**Subject: Palo Verde Nuclear Generating Station (PVNGS)  
Units 1, 2, and 3  
Docket Nos. 50-528/529/530  
Response to Request for Additional Information  
Concerning Floor Response Spectra For Seismic Qualification  
of Batteries at PVNGS - TAC No. M86200  
File: 94-010-026**

**REQUEST FOR ADDITIONAL INFORMATION  
CONCERNING FLOOR RESPONSE SPECTRA FOR  
SEISMIC QUALIFICATION OF BATTERIES AT  
PALO VERDE NUCLEAR GENERATING STATION**

**Floor Response Spectra for Seismic Qualification of AT&T Round Cell Batteries at  
Palo Verde Nuclear Generating Station (PVNGS)  
TAC No. M86200**

FIG. II(a)

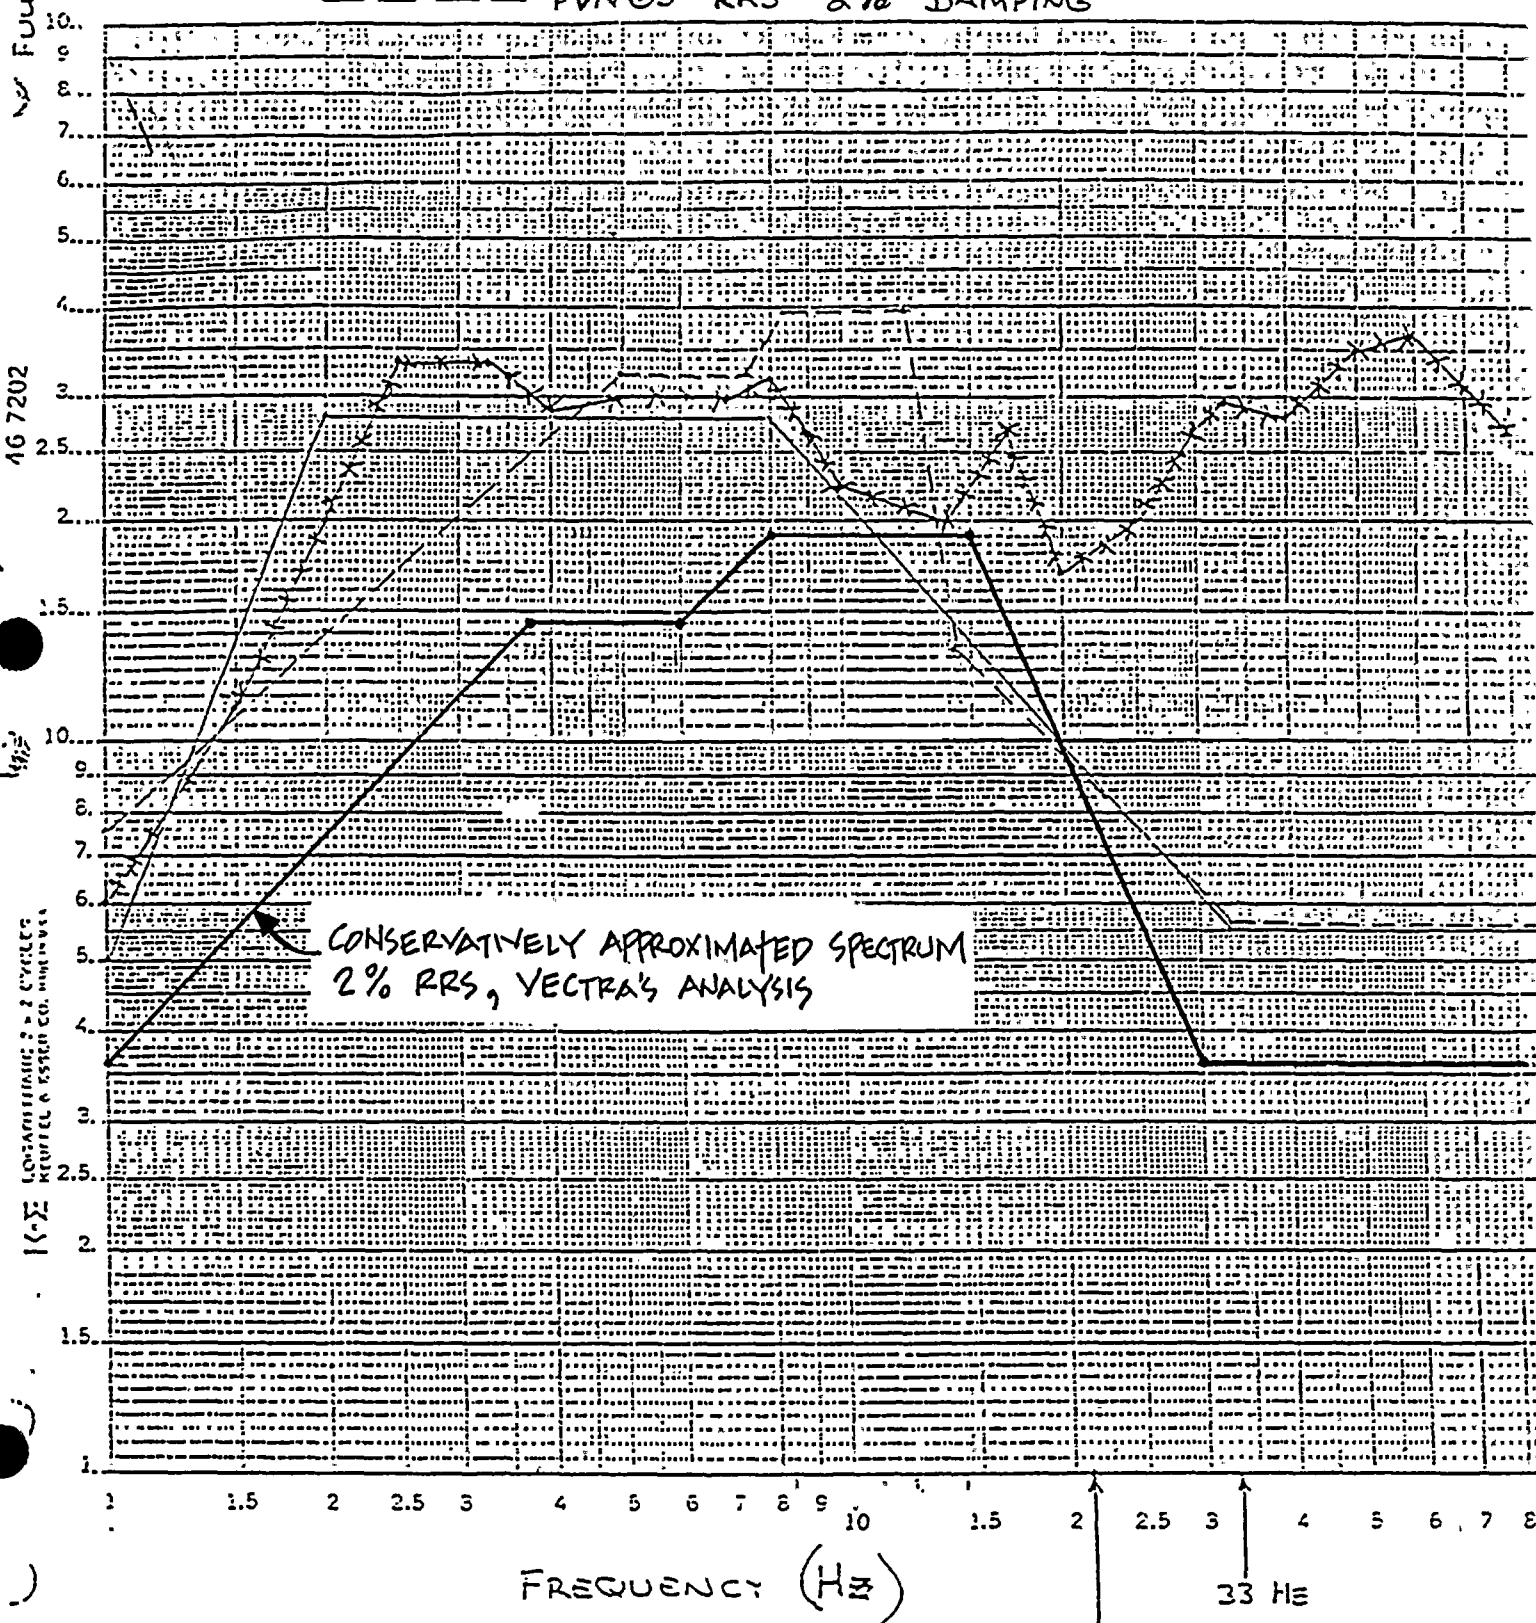
Vertical floor response spectrum (2% damping) at the batteries' locations of the structure which can be utilized for comparison with the TRS in Figure IIa (Reference 7).

A review of VECTRA's analysis of the Control Building reveals that PVNGS design basis response spectra for elevation 100' are very conservative. VECTRA's analysis also reveals that vertical SSE (increased by 20% for a PGA of 0.25g) and RLE response spectra for elevation 100' of the Control Building, at the batteries' locations, are enveloped by the vertical Test Response Spectrum (TRS) for the batteries. This is shown in Attachment B.

Vertical floor response spectra (2% damping) at the batteries' locations from analysis that was performed by VECTRA are provided in Attachment E. Vertical floor response spectrum (2% damping) at the batteries' locations was not generated in Bechtel's Study No. 13-CS-102.

**Vertical Synthetic Time History**

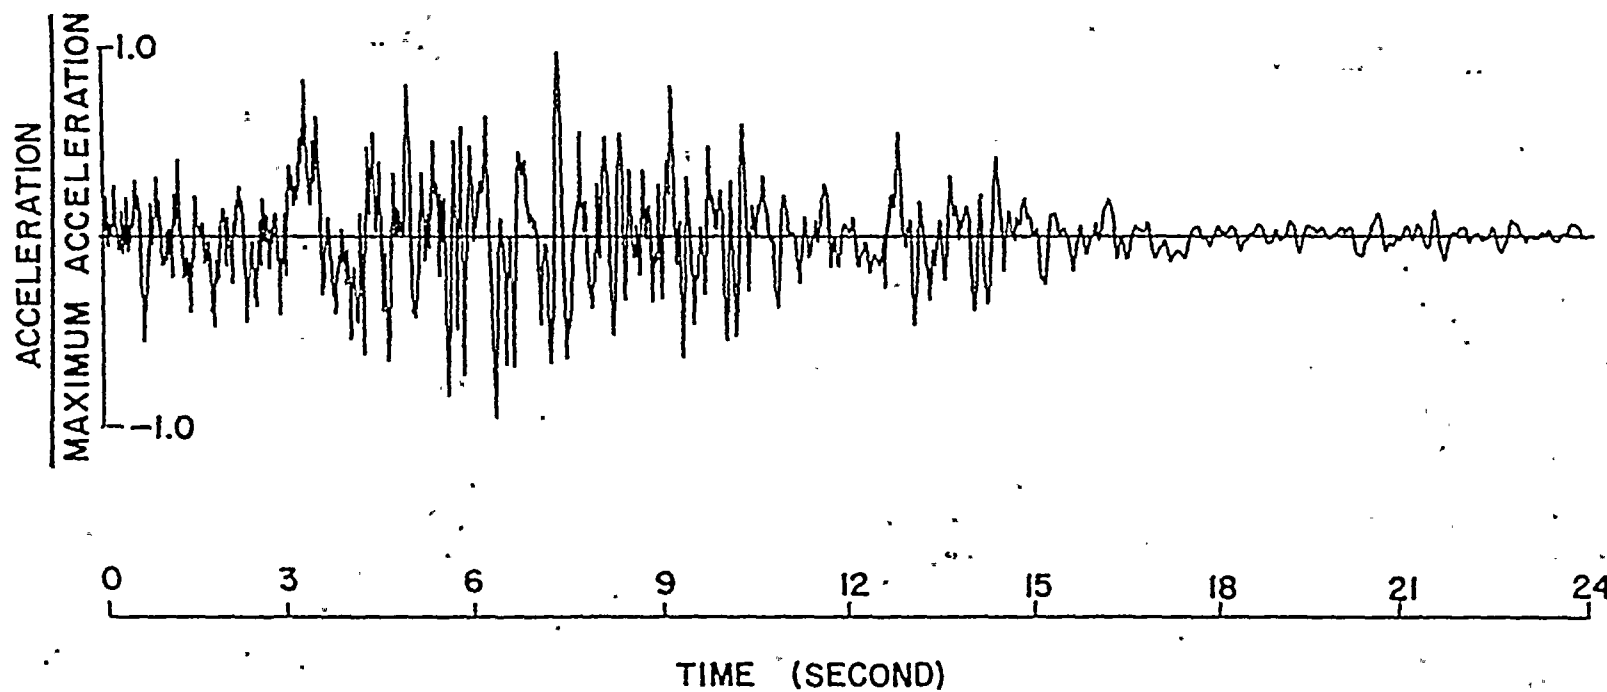
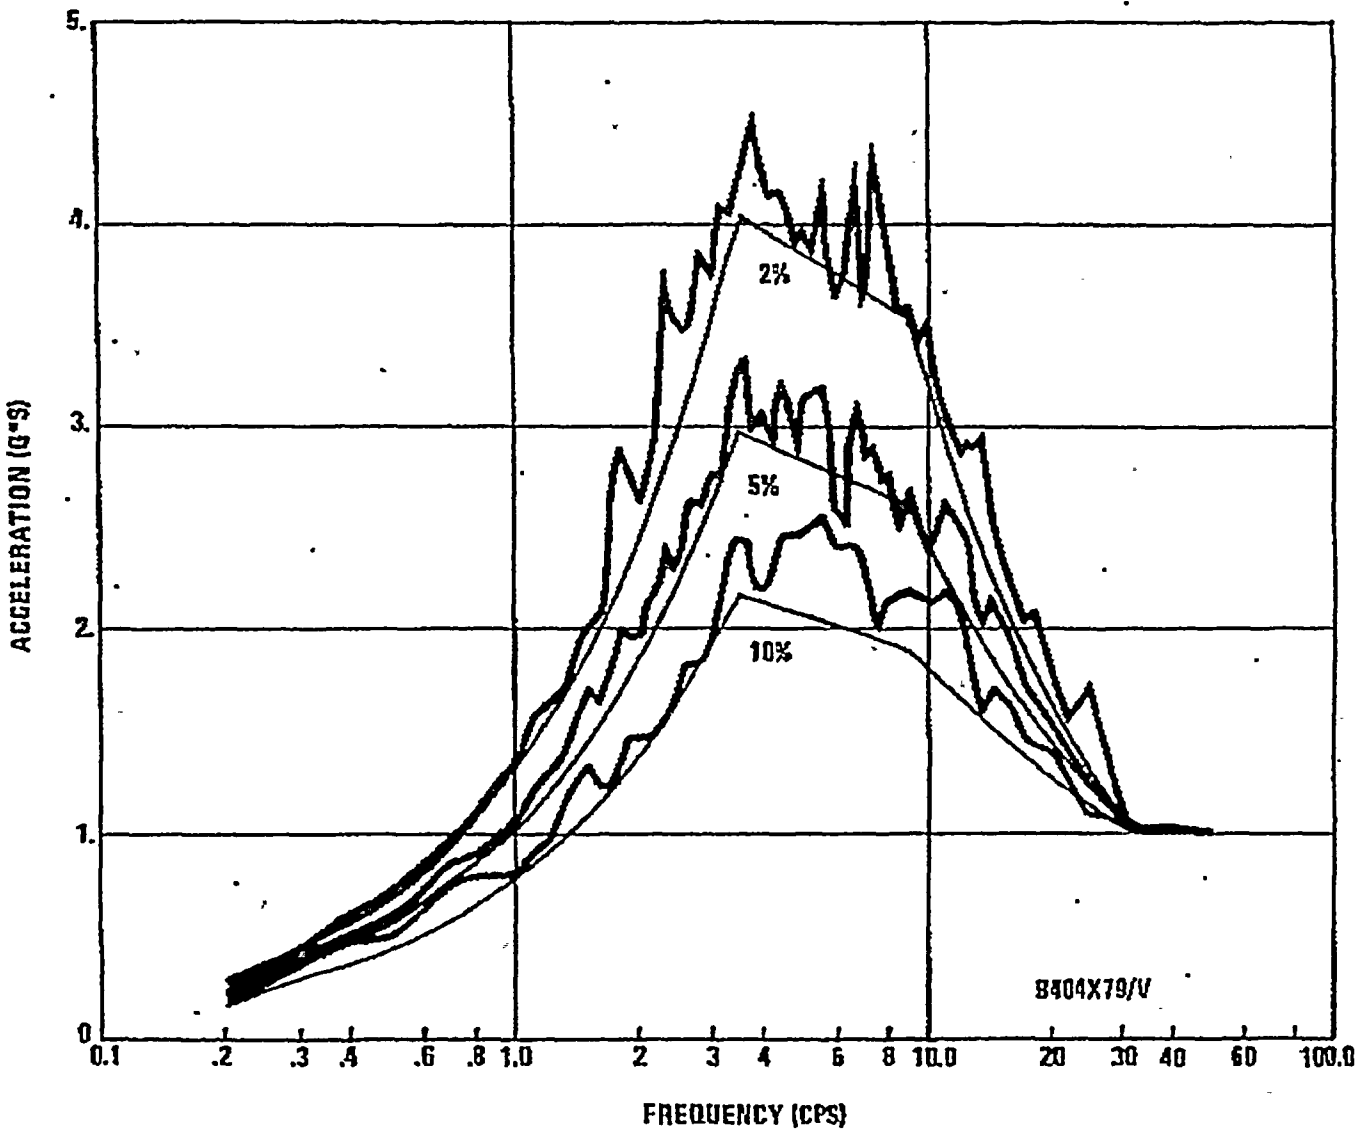
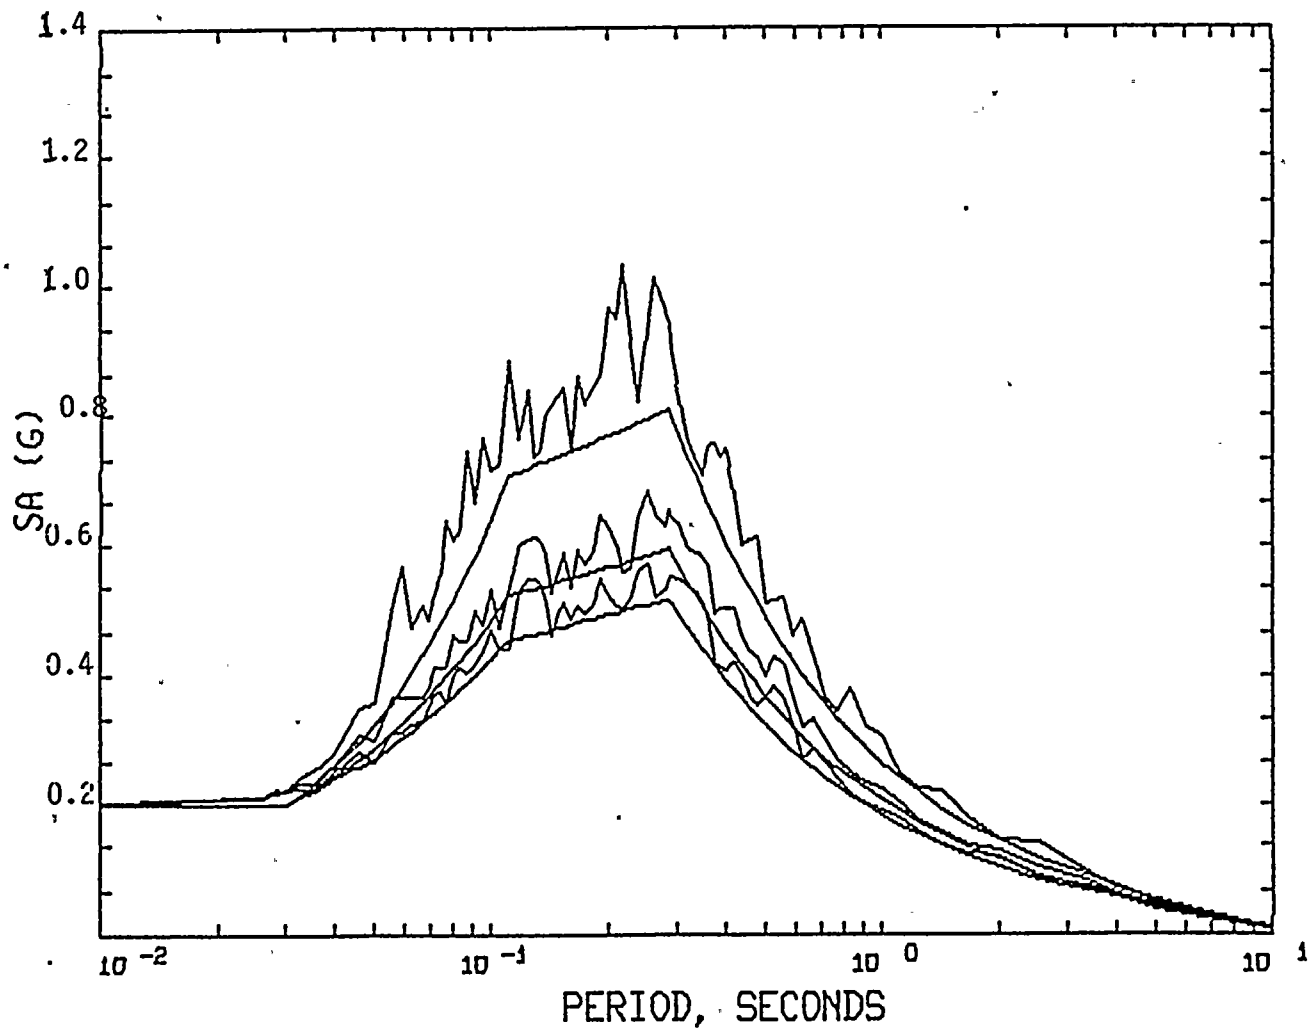
Synthetic time-history (vertical) at the grade level.

Synthetic time-histories (vertical) at the grade level from analyses that were performed by Bechtel and VECTRA are provided in Attachment C.

**Vertical Response Spectra at the Foundation Level and 60% of the Design Ground  
Response Spectrum**

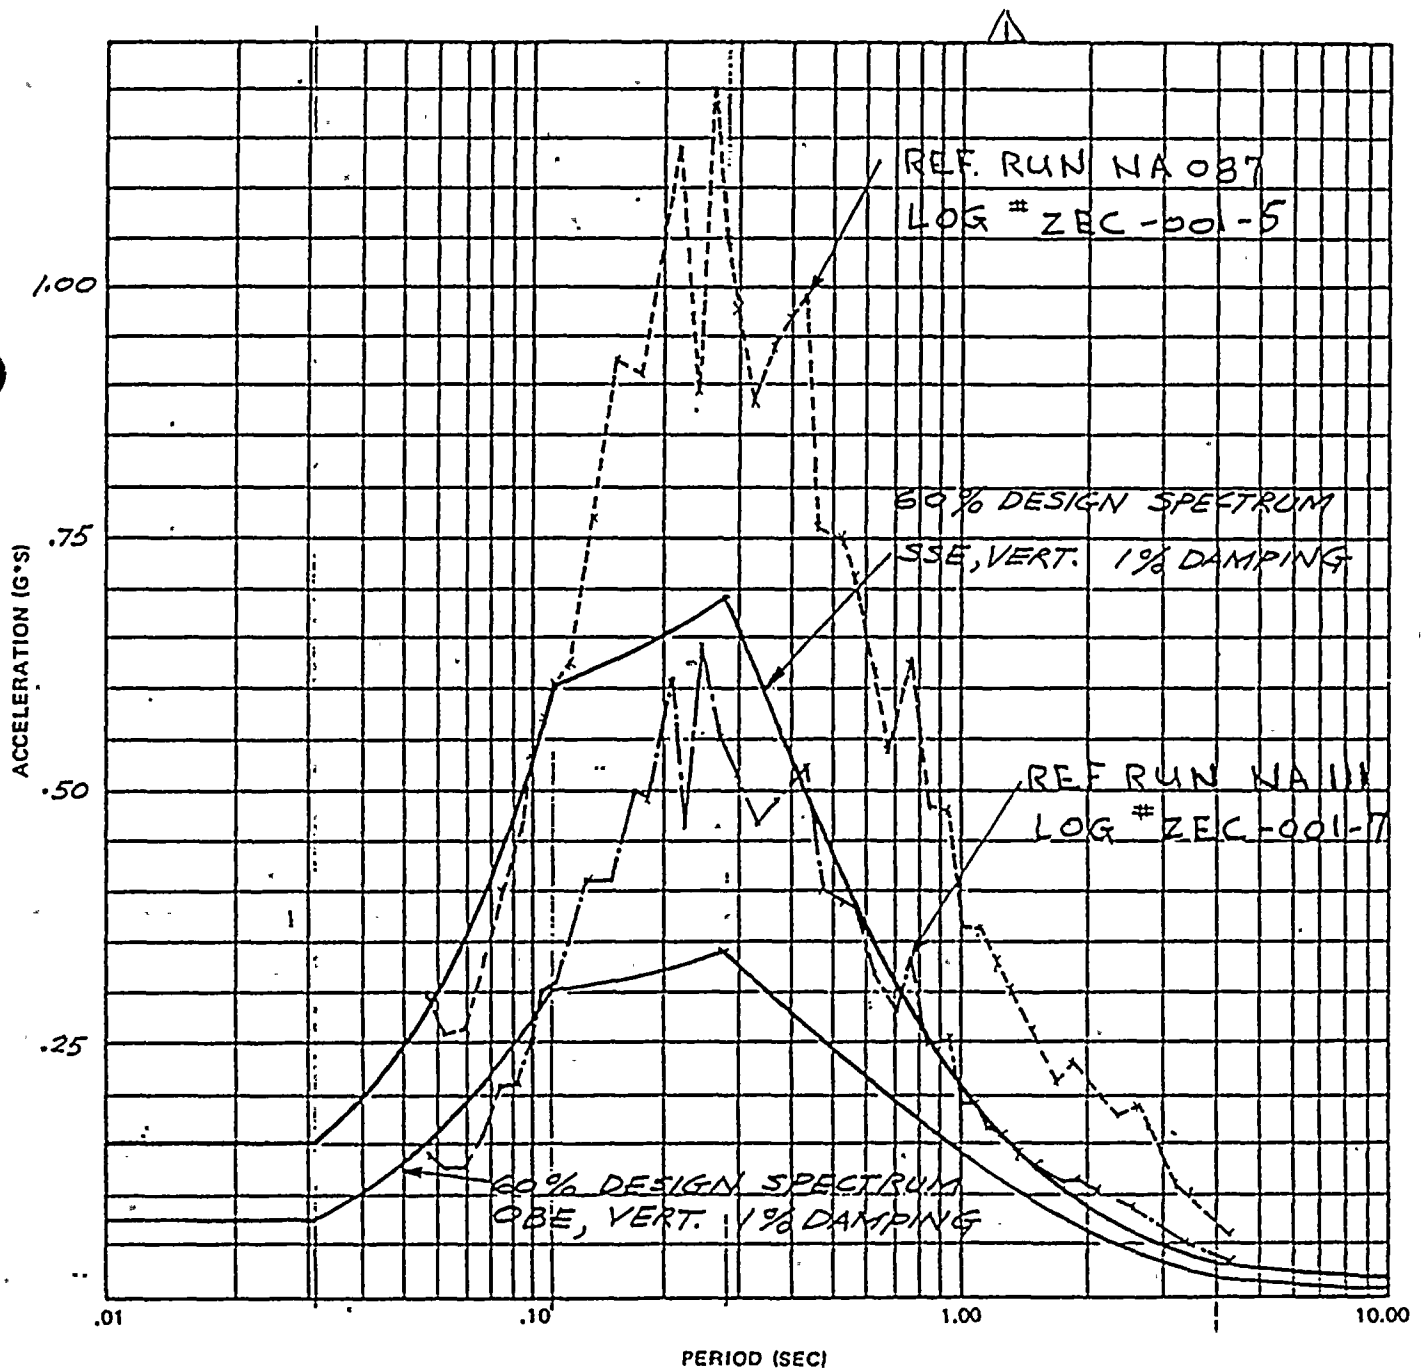
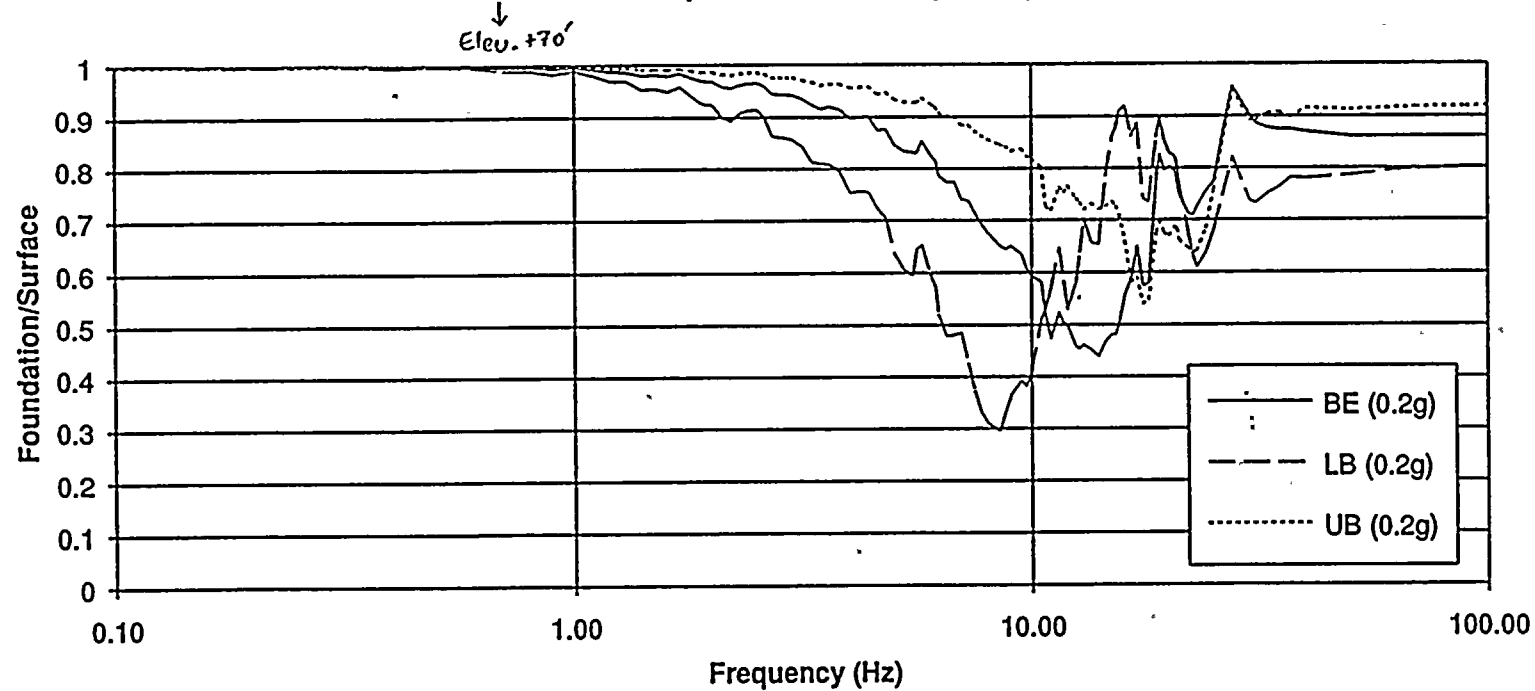
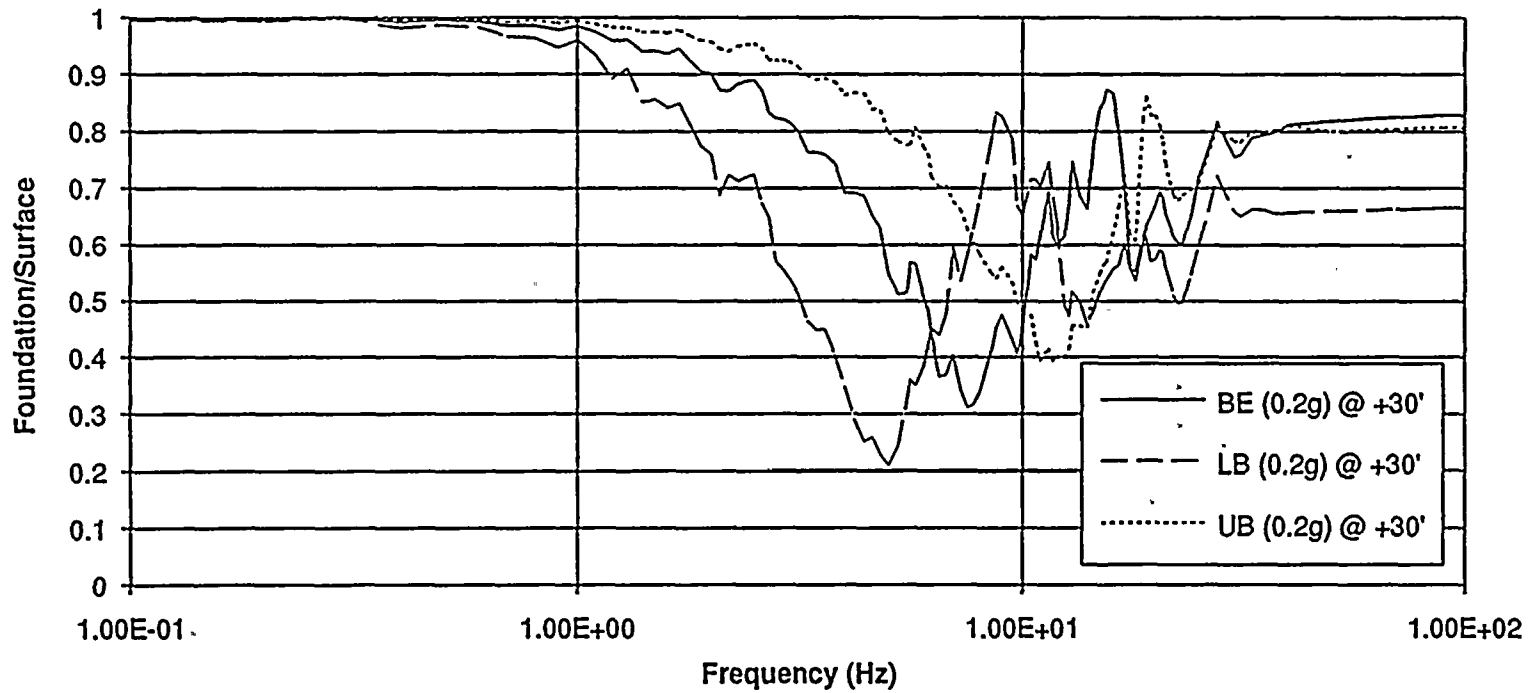
Vertical response spectra at the foundation level and 60% of the design ground response spectrum.

The vertical response spectra at the foundation level and 60% of the design ground response spectrum from analyses that were performed by Bechtel and VECTRA are provided in Attachment D.
